Well Name: GORDON	Well Location: T27N / R10W / SEC 22 / NESE / 36.557434 / -107.877136	County or Parish/State: SAN JUAN / NM
Well Number: 1R	Type of Well: CONVENTIONAL GAS WELL	Allottee or Tribe Name:
Lease Number: NMSF077952	Unit or CA Name:	Unit or CA Number:
US Well Number: 3004523764	Operator: HILCORP ENERGY COMPANY

Sundry ID: 2851283
Type of Submission: Subsequent Report
Date Sundry Submitted: 05/06/2025
Date Operation Actually Began: 04/30/2025
Type of Action: Plug and Abandonment
Time Sundry Submitted: 09:54

GORDON 1R

PLUG & ABANDON

Current Schematic - Version 3

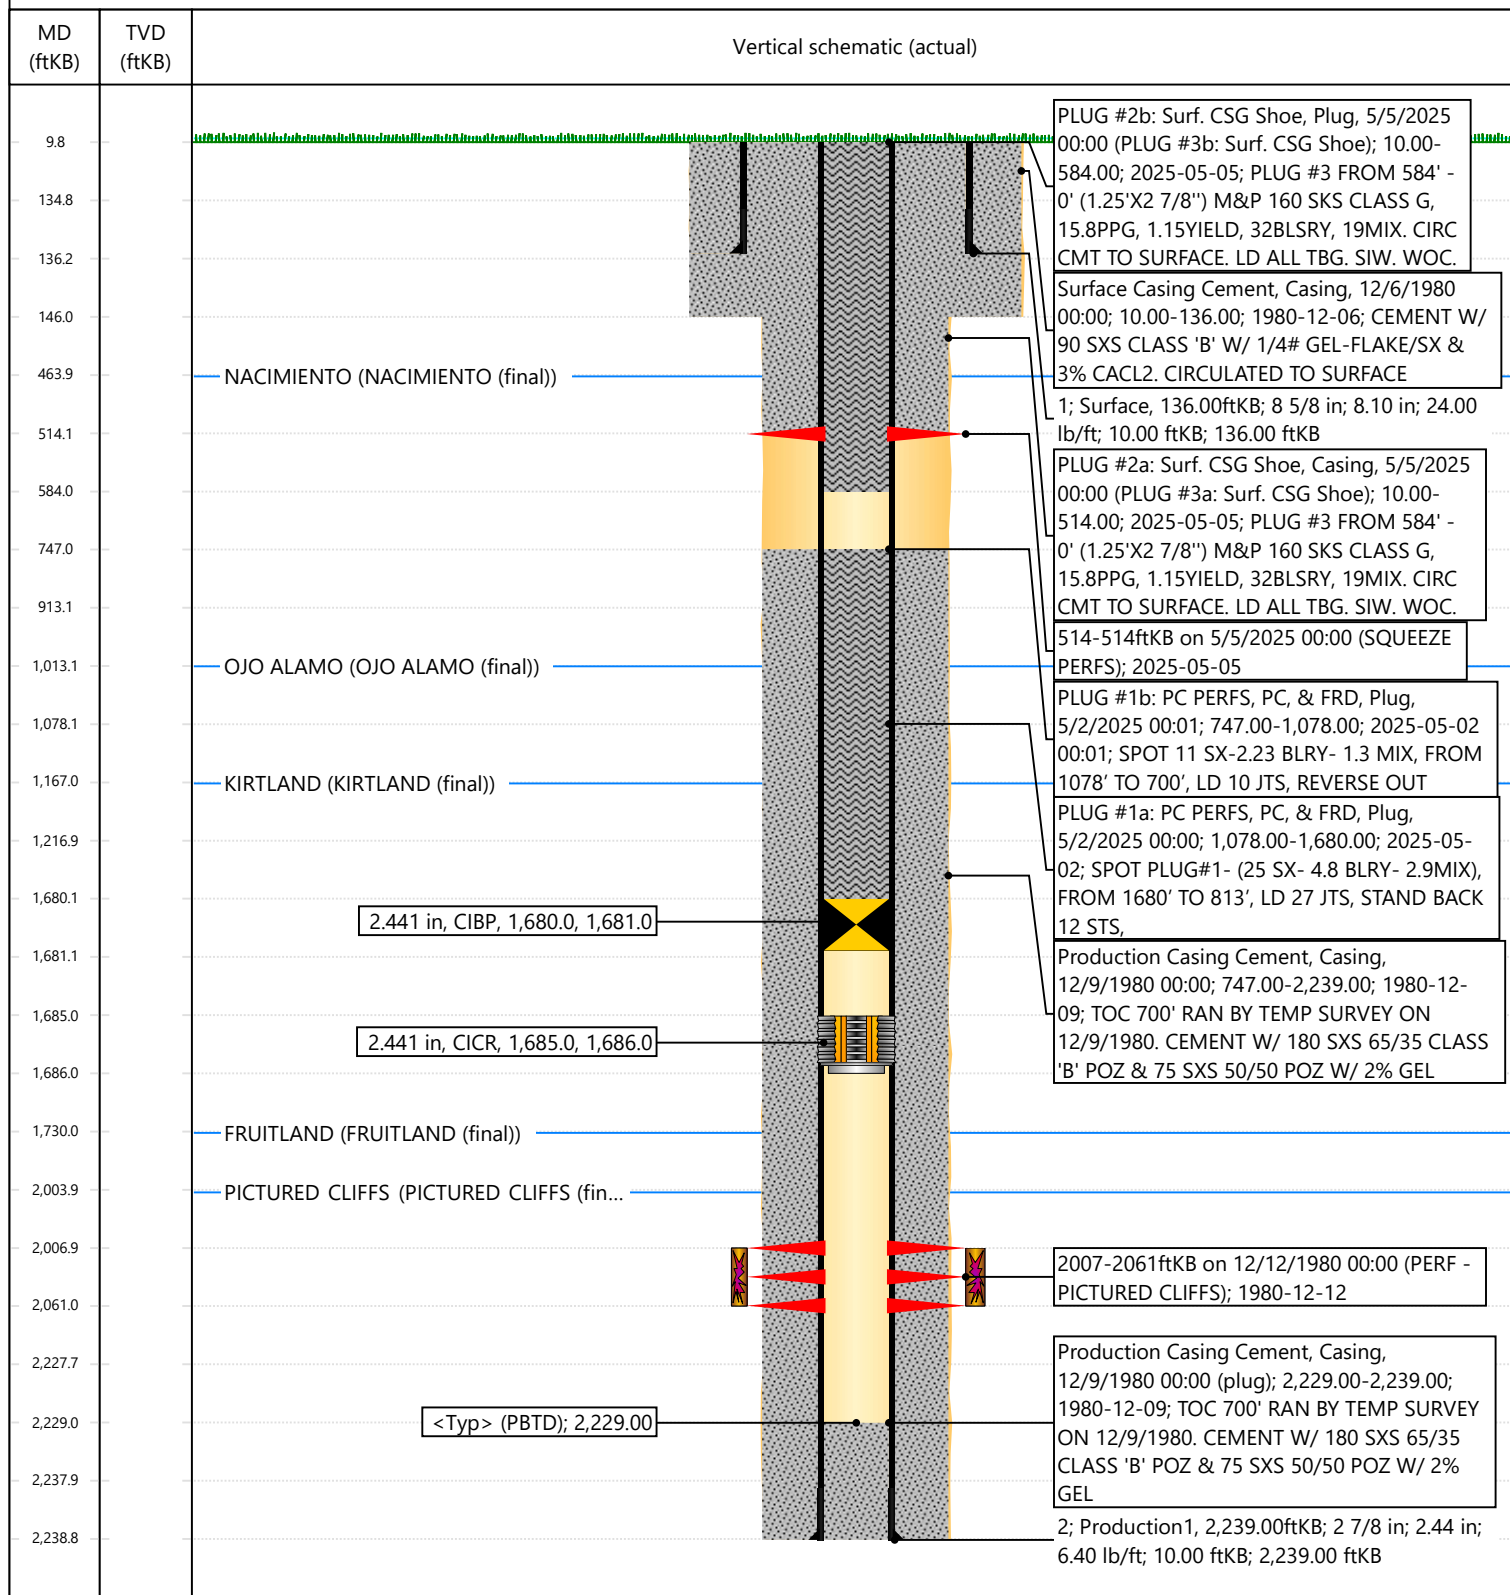
As discussed today, to accommodate the COA's, I made the following changes to PLUG #1 of this procedure: set a CICR 7' above the PC, pump 67' of cement below, set a CIBP 10' above the retainer, and pump 357' of cement on top of the bridge plug to cover the Fruitland by 100'. I have attached the revised procedure/schematics as well as the approved NOI.

The BLM approves of the updated procedure.
